**Redcar & Cleveland Borough Council**  
**Adults and Communities**

# Memo

## Environmental Protection Planning Consultation Response

<b>Proposal:</b>	<b>PARTIAL DISCHARGE OF CONDITION 17 (REMEDIATION STRATEGY) OF OUTLINE PLANNING PERMISSION R/2020/0357/OOM FOR DEMOLITION OF EXISTING STRUCTURES ON SITE AND THE DEVELOPMENT OF UP TO 418,000 SQM (GROSS) OF GENERAL INDUSTRY (USE CLASS B2) AND STORAGE OR DISTRIBUTION FACILITIES (USE CLASS B8) WITH OFFICE ACCOMMODATION (USE CLASS B1), HGV AND CAR PARKING AND ASSOCIATED INFRASTRUCTURE WORKS ALL MATTERS RESERVED OTHER THAN ACCESS</b>
<b>Premises:</b>	<b>South Tees Development Corporation, Trunk Road, Redcar, TS10 5QW</b>

Figure 2

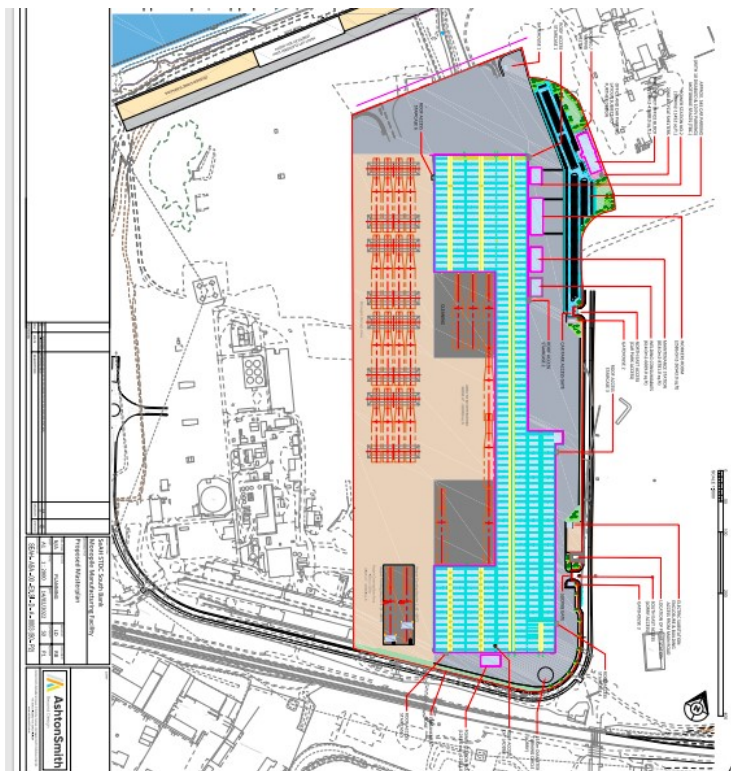
However, the Clarkebond remediation design statement includes the coke ovens shown the proposed masterplan in Figure 2

The remediation design strategy is acceptable to partially discharge condition 17 however, this is only currently applicable to the area enclosed by the black boundary line as denoted in Figure 3.
